SITE PLAN REVIEW AND APPEARANCE BOARD

File No: 2019-147-SPF-SPR-CLV

Application Name: OSC Townhomes – 202 SE 4th Avenue

SITE PLAN

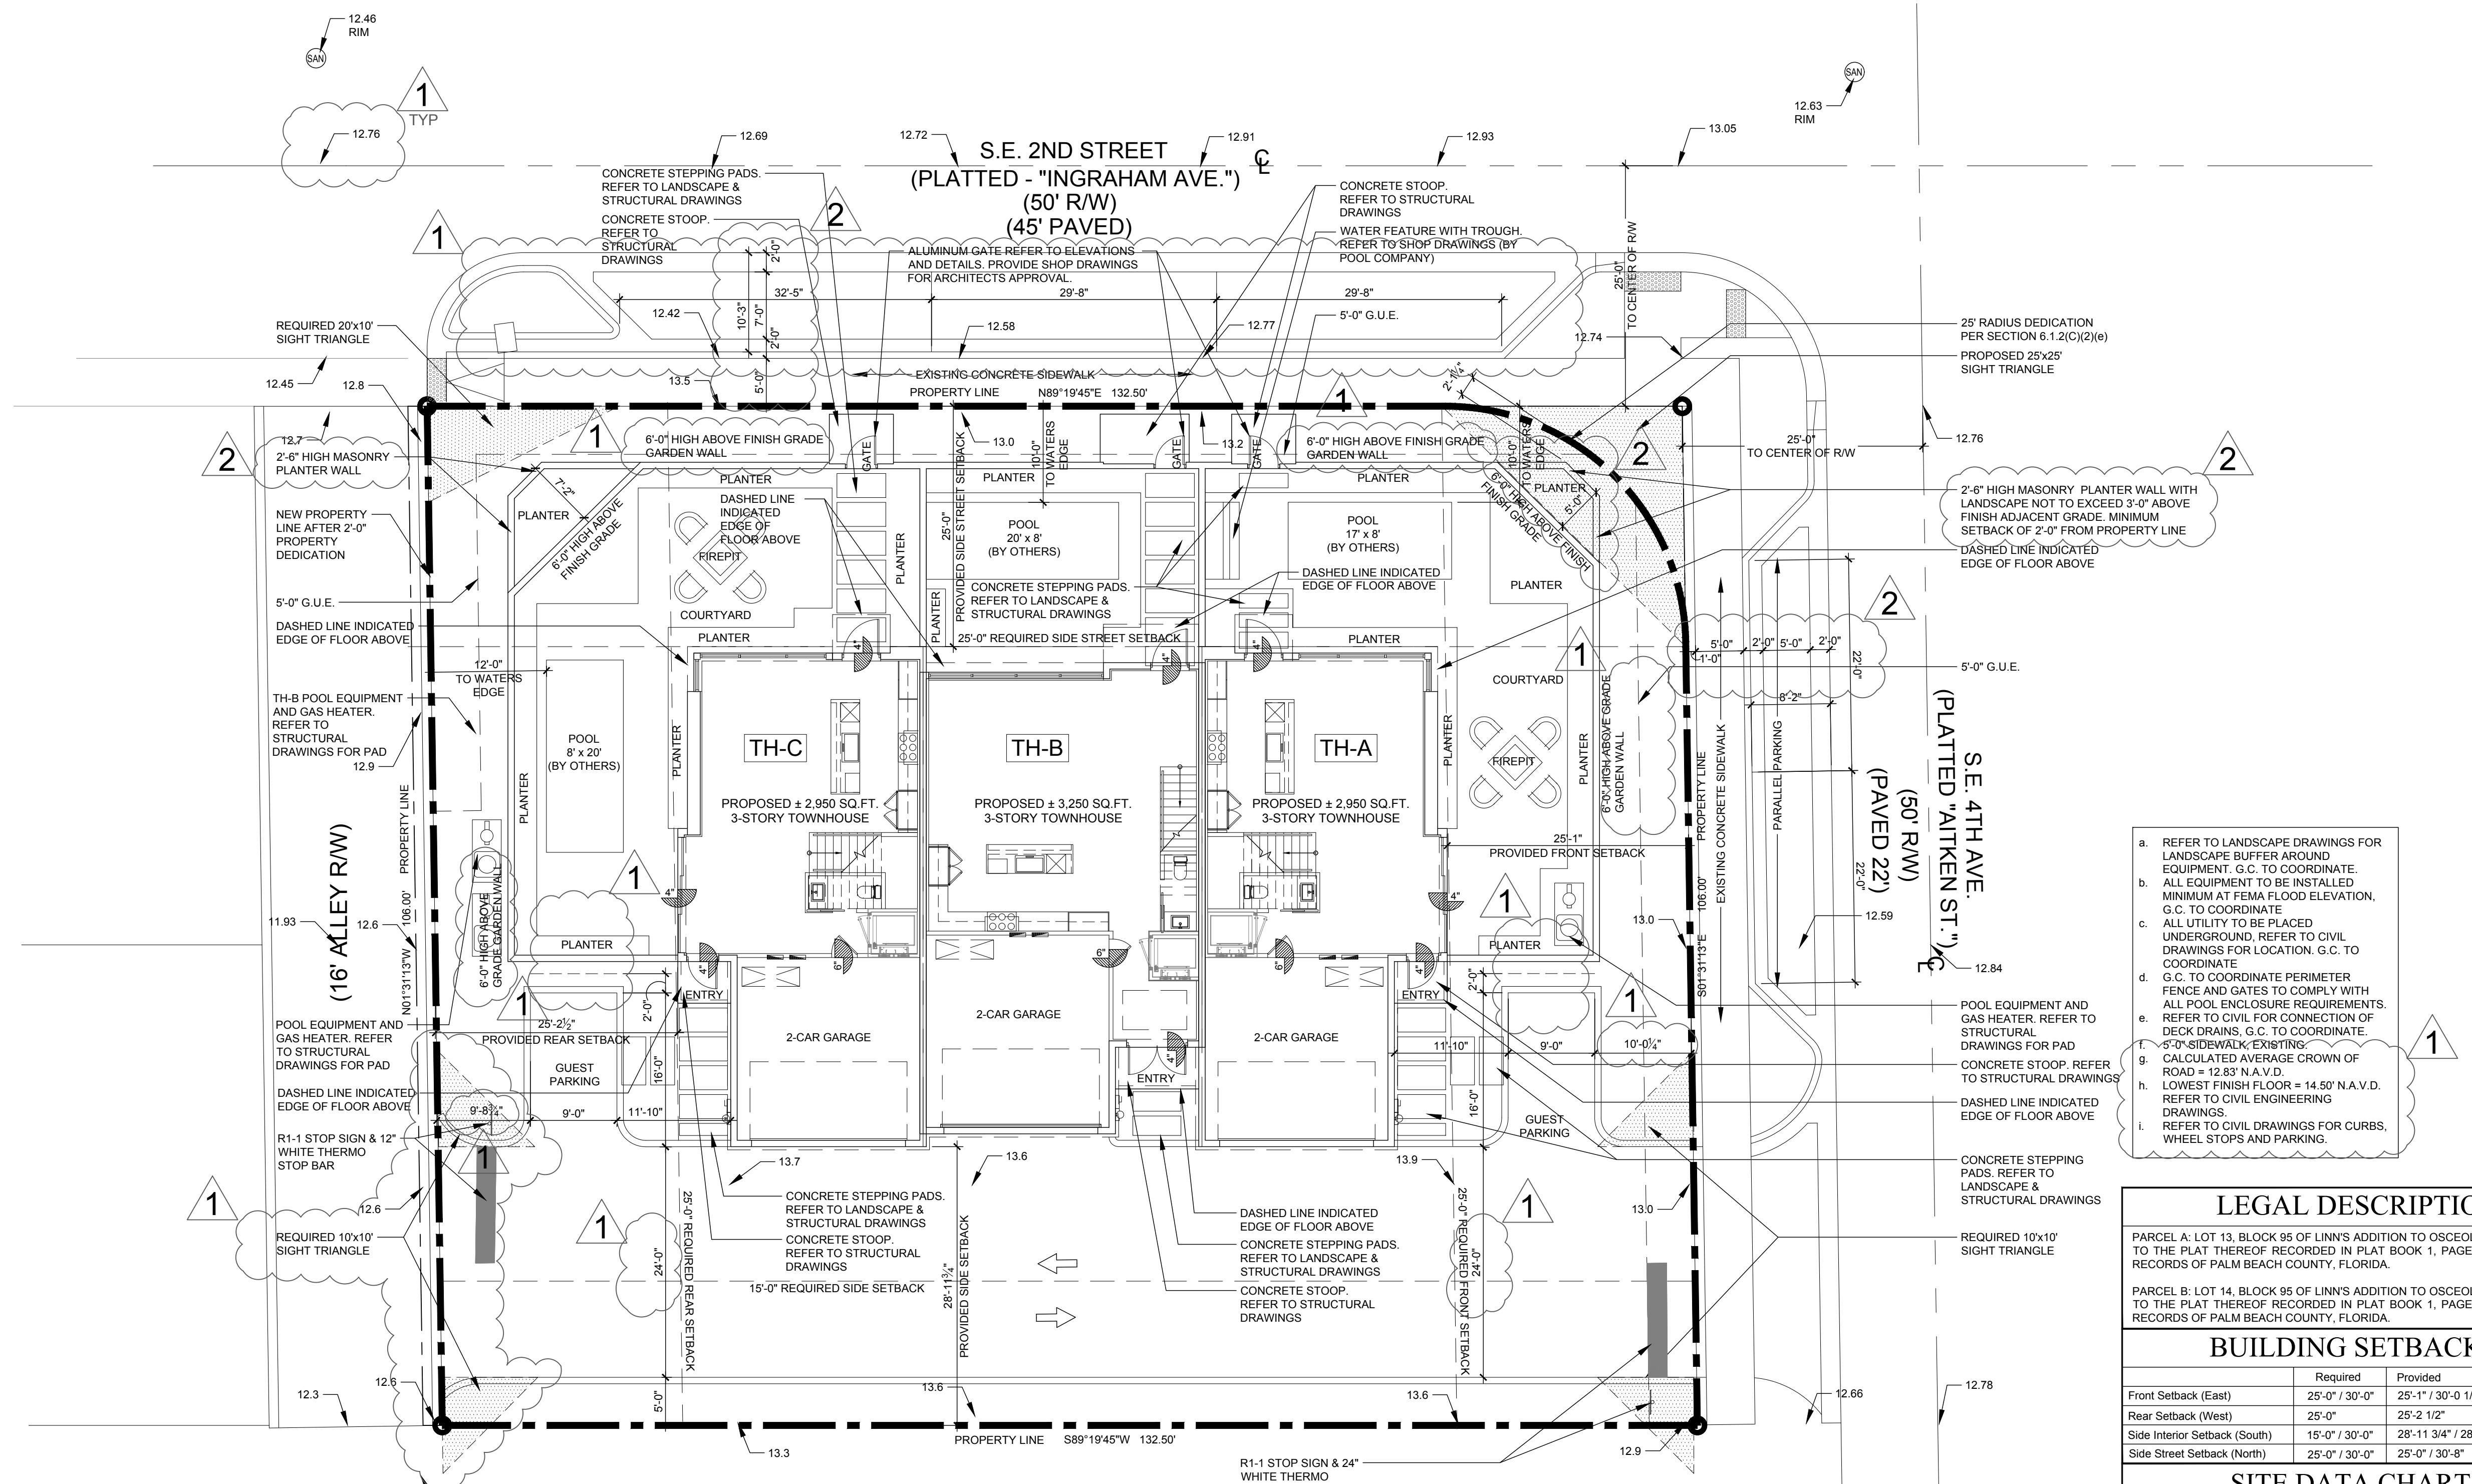
- As shown on page SP-1, the townhomes facing SE 2nd Street have a 2-car garage with a setback of at least 25', thus complying with this requirement.

- Site plan SP-1, shows a 6' high masonry screen wall adjacent to the front yard, side street, and rear yard setbacks. The wall is offset approximately 6' from the property line to allow for landscaping to grow in the front of the walls. Furthermore, the north property line contains two triangular landscape planter beds contained in a 3' tall masonry planter. As shown on page L-2, the proposed Fakahatchee Grass plants shown to screen the concrete walls are identified to be installed at 24" in height at time of planting. The plant material selected in accordance with LDR Section 4.6.5 (E), will grow to a mature height within two years, to be maintained at a height half the size of the wall. The proposed wall and hedge heights comply with the aforementioned LDR section.

- Site Plan page SP-1 shows a 9.8' stacking distance on the west side of the property from the alleyway to the first parking guest parking space, and a 10.3' stacking distance on the east side of the property from SE 4th Avenue (local road) to the first parking spaces. The proposed stacking distances exceed the minimum requirement listed above.

- Site plan page SP-1 shows three private swimming pools on the site. As a result of the limited access easement being provided along the north side of the property, the north side of the property is considered the side street setback, and the west side of the property is considered the rear setback. As shown, the proposed pools for unit TH-A and TH-B are located within the side street back, 10' from water's edge to the property line. The pool shown adjacent to unit TH-C in the rear setback is shown to be 11' from the property line.

- As shown on page SP-1, the existing alleyway is shown to be 16'. As such, the plans show the development is providing a 2' dedication along the alleyway to contribute to the required 20' ROW minimum requirement for alleys in accordance with 5.3.1(D)(2) Table T-1.

planting
plan

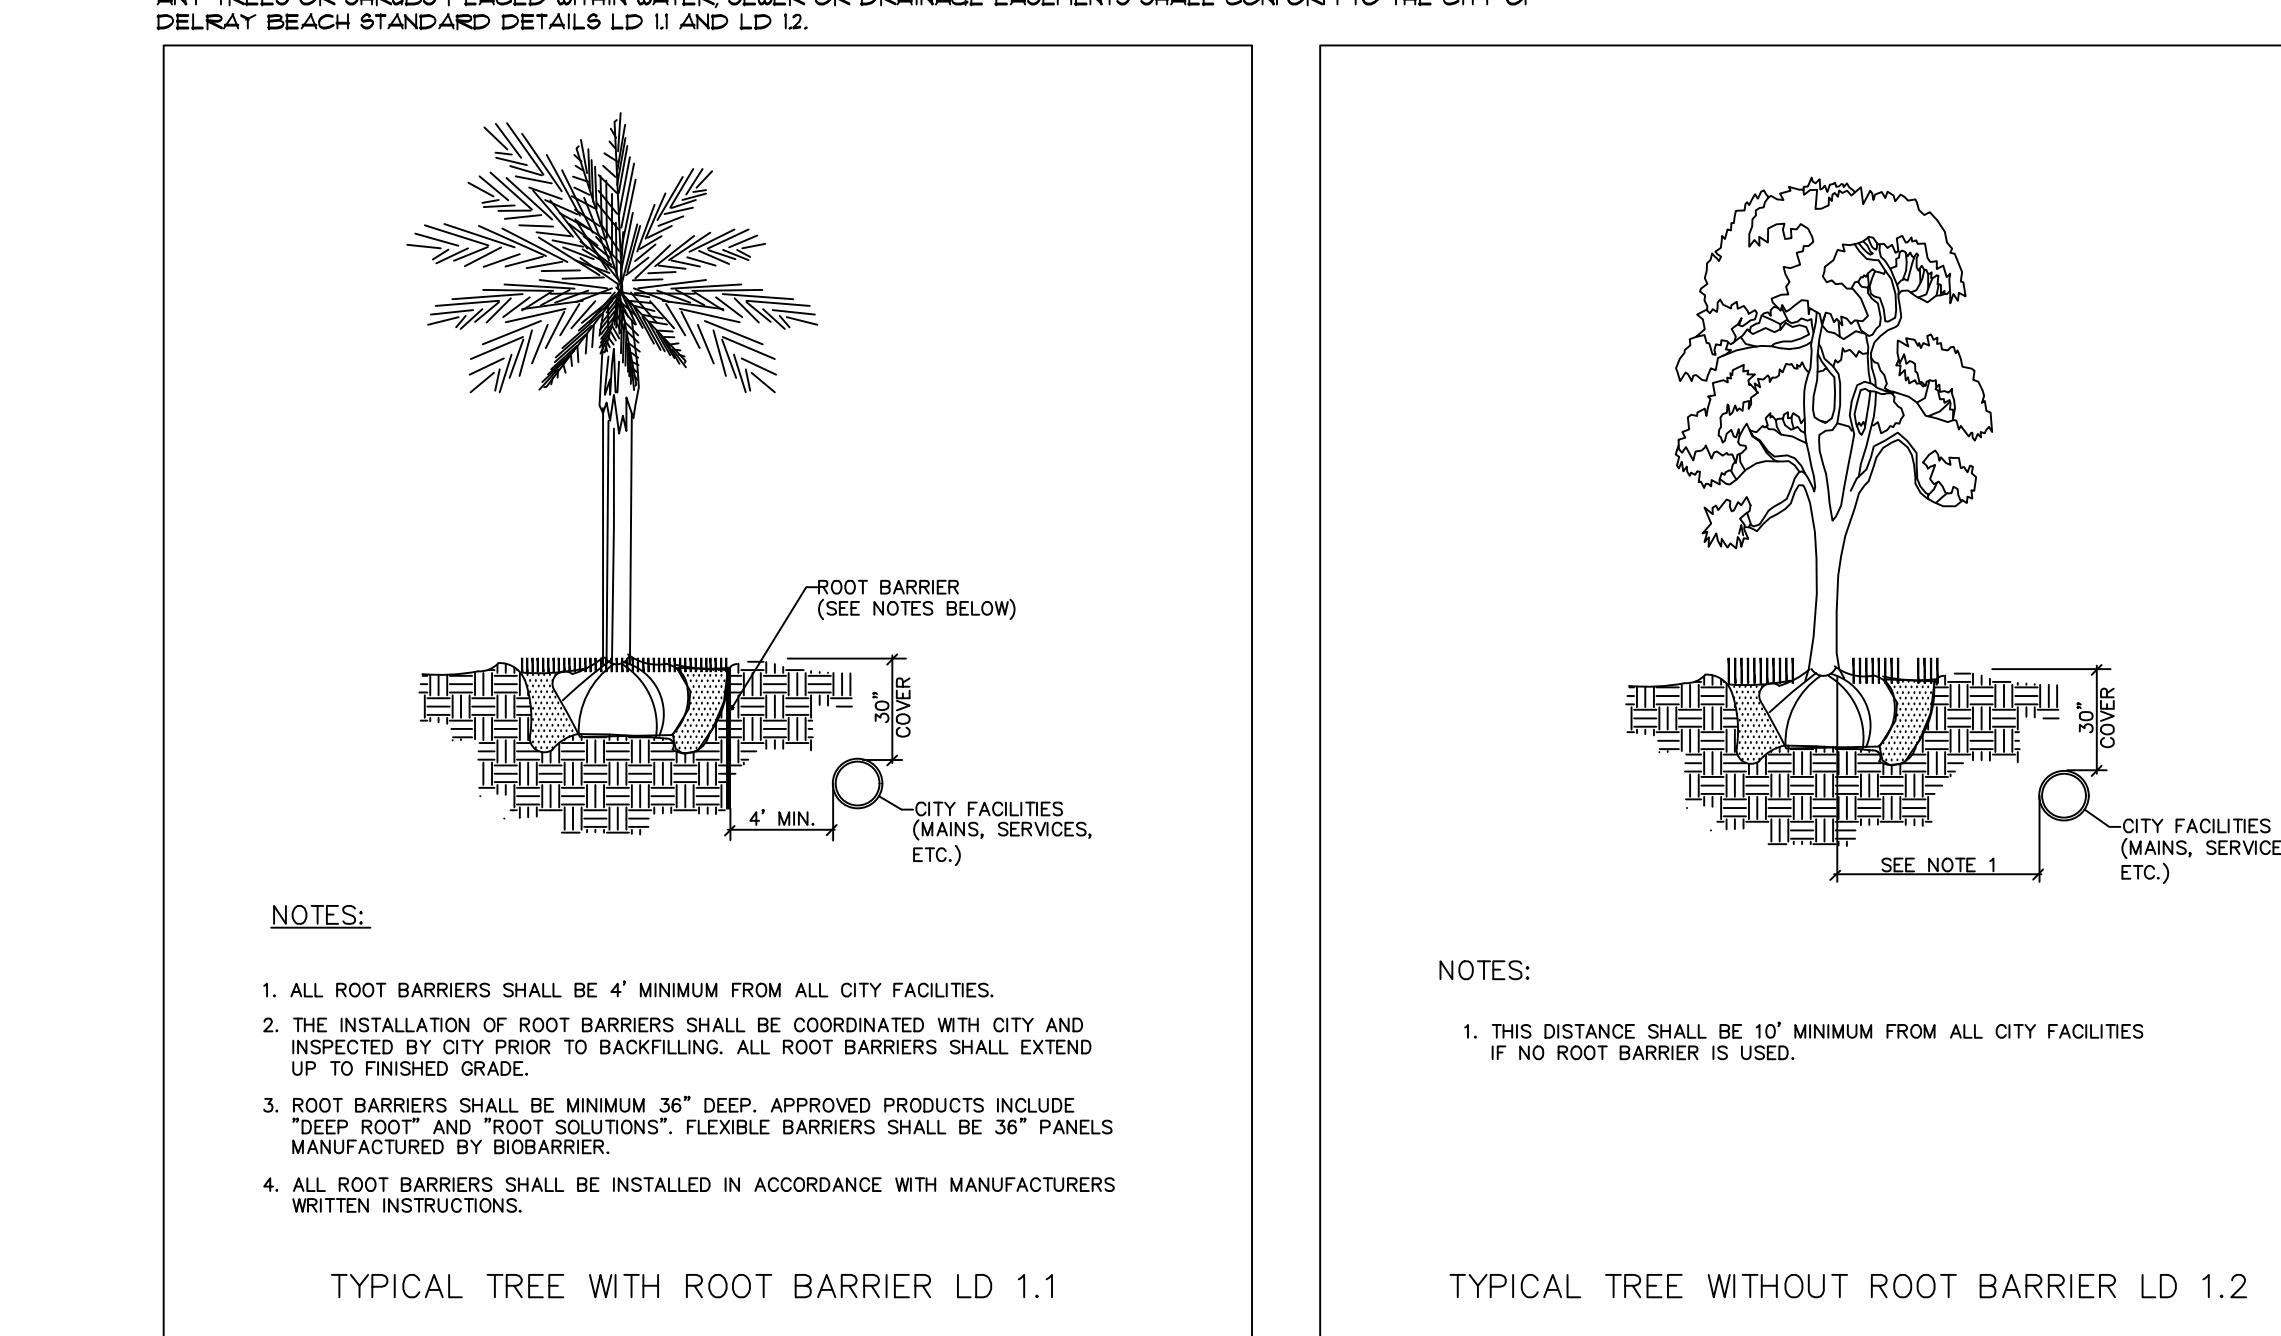
Specifically, plan page L-2 shows a row of 13 trees adjacent to the south property line placed 8' to 14' feet on center to create a dense continuous buffer of trees. The trees provided will be made up of canopy trees and palm trees. The Holly trees are specified at a height of 20', Fishtail Palm are specified

at 16' in height, and the Sable Palms are specified at a height of 26'. The Sable Palms and the Holly trees specified are over 25% larger in height than what is specified in the code as required in this LDR section.

one Cabbage Palm tree. Furthermore, the plan shows the removal of two Seagrape trees and one Green Buttonwood tree. Plan page L-2 shows a lush variety of native and Florida Friendly landscape material proposed for the development. The quantity and size comply with the minimum requirement listed in the LDR. The landscaping selected along SE 2nd Street and SE 4th Avenue are composed of a row of Solitaire Palm trees with ornamental grasses and foundation plant material. The two corners of the property adjacent to SE 2nd Street feature raised triangle planter beds in front with Sylvester Date palms, which aesthetically frame from the front of the buildings. Along the west property line, a row of Sable palm trees with foundation plants and ornamental grasses buffer the property from the adjacent alleyway. As previously mentioned, adjacent to the south property line features a row of East Palatka Holly trees spaced 15' on center, Sable Palms spaced 8' on center and a continuous row of shrubs. Additionally, the landscape material provided along the south property line provides a buffer from the higher density use of the subject property to the lower density Single-Family zoned properties to the south.
